BURRUNDULLA MINI SUSTAINABLE ENERGY PARK
3B CASTLEREAGH HIGHWAY, BURRUNDULLA
LOT 6, DP1069441

TRAFFIC ASSESSMENT REPORT

TRAFFIC MANAGEMENT REPORT SUPPLEMENTARY INFORMATION

Triaxial Consulting have been engaged to respond to Traffic for NSW (TfNSW) comments provided in correspondence provided by TfNSW reference: SF2019/129237; WST19/00146/02 dated 21 July 2020.

APPENDIX B - TRIAXIAL PLAN MX10595.00-CM1.0

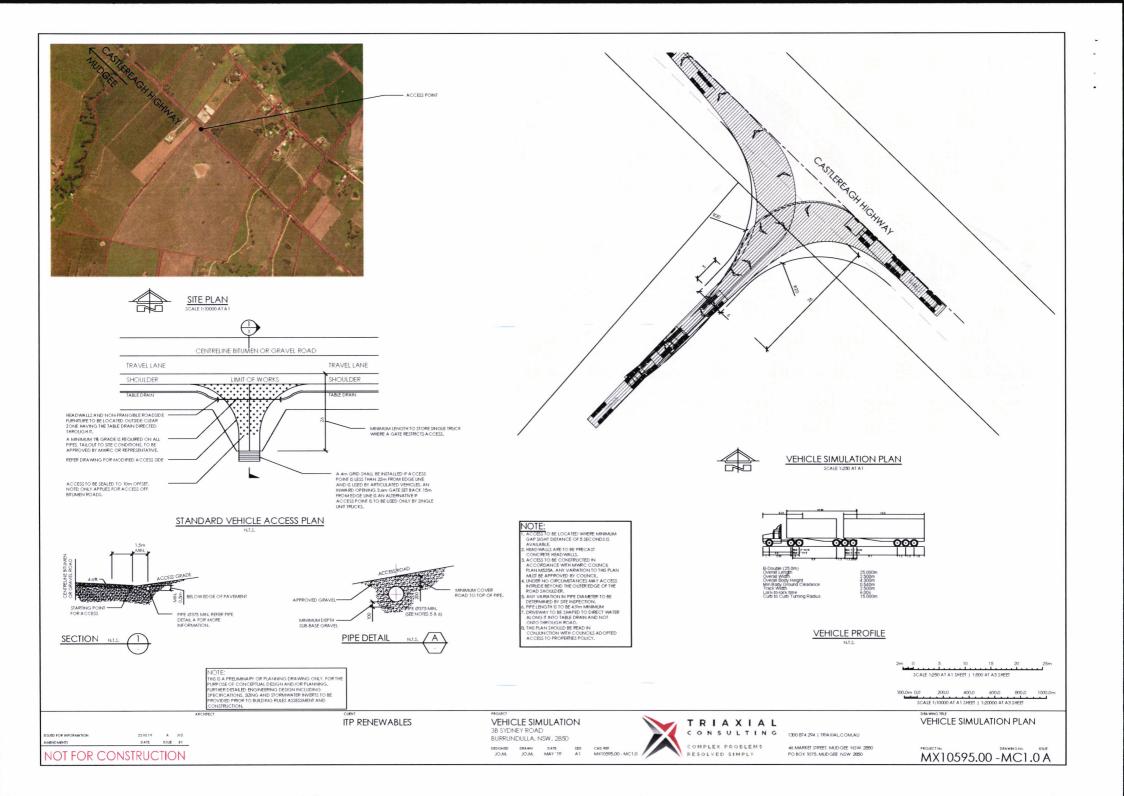
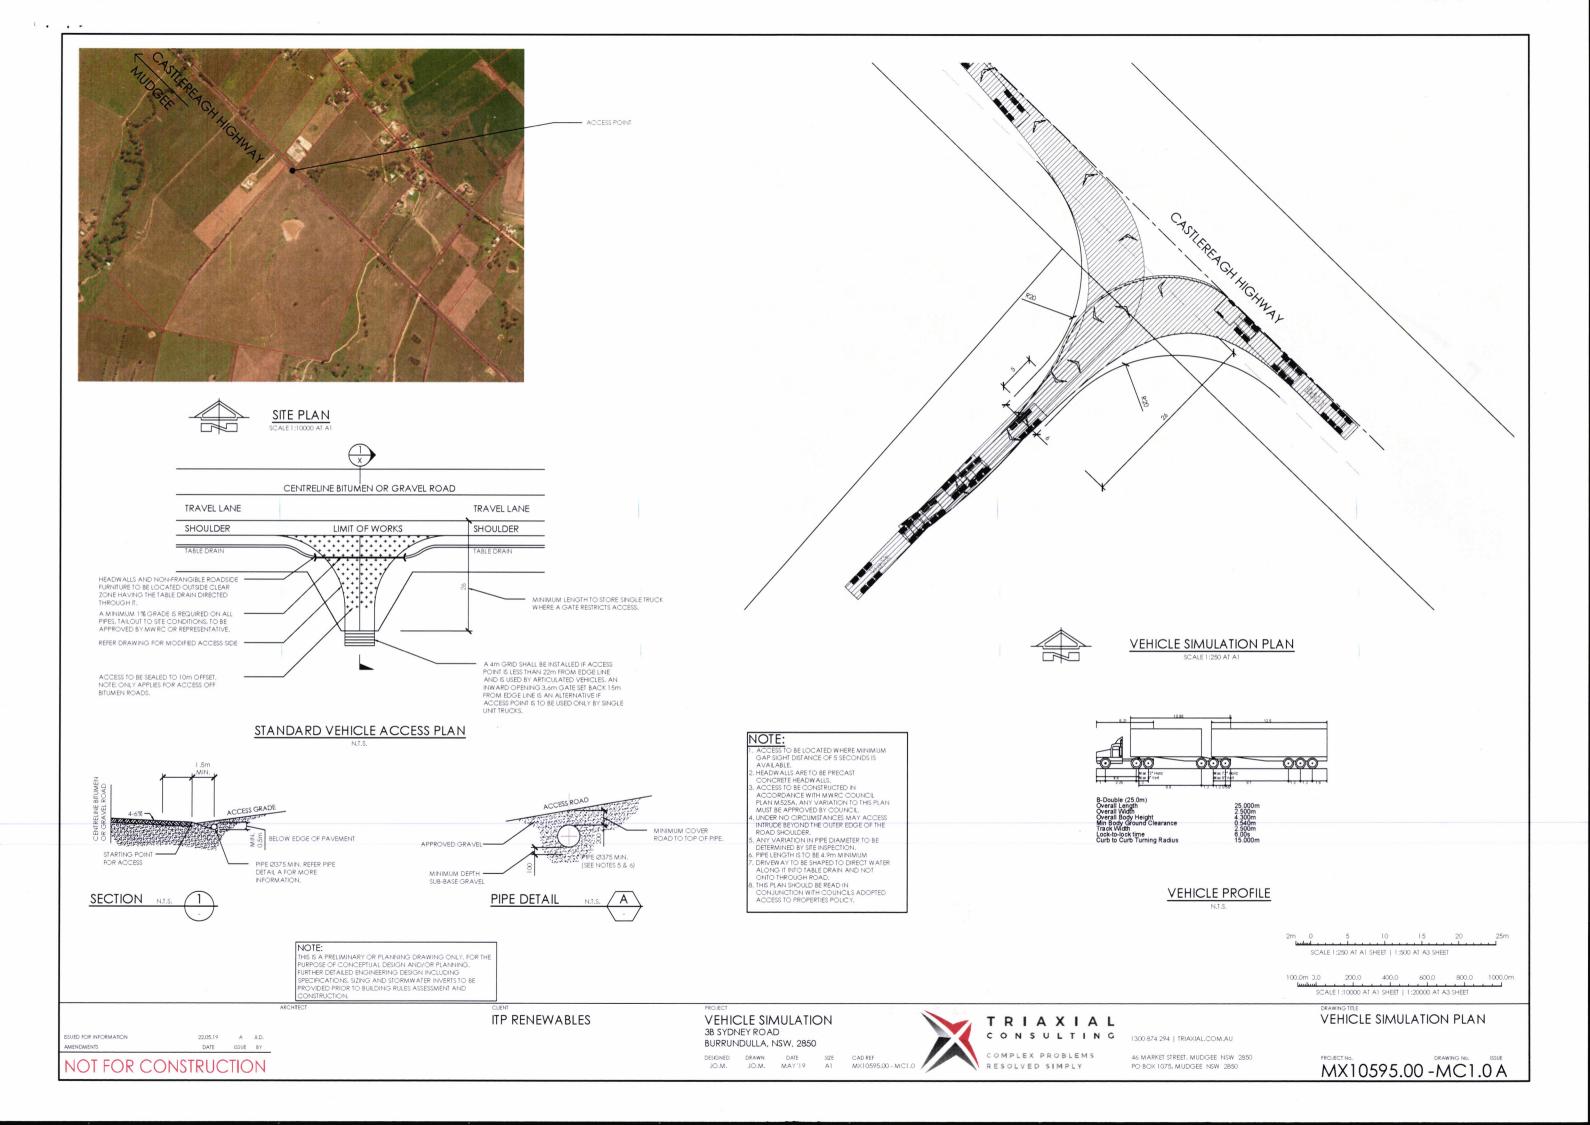
The purpose of this revised report is to assess the proposed new site entrance location to the Solar Farm development. Concerns were raised by TfNSW as to the proximity of existing property access points. The site access location has now been proposed to be moved further South away from existing property access locations to increase the safety of the new access point.

As previously mentioned the proposed site access location has been refined to distance the access point from existing property access locations along the Highway.

Nearby accesses at the proposed site entrance location include the entrance to a private residence on the opposite side of the Highway 310m to the North (formerly entrance to nursery that has since ceased operation) and another private residence entrance point located on the opposite side of the road approximately 145m to the South.

Triaxial plan MX10595.00-MC1.0 issue C is provided along with this report and includes updated information on the site entrance location.

Entry points for each of the above neighbouring businesses are shown on Triaxial plan MX10595.00-MC1.0 issue C.

Based on the limited number of construction vehicles turning into the site during the construction phase of the project that will be outside of peak hour vehicle trips along Castlereagh Highway we consider that the property entrance upgraded to a full BAL / BAR intersection will provide an adequately safe entrance for the expected volume of traffic to use the facility.
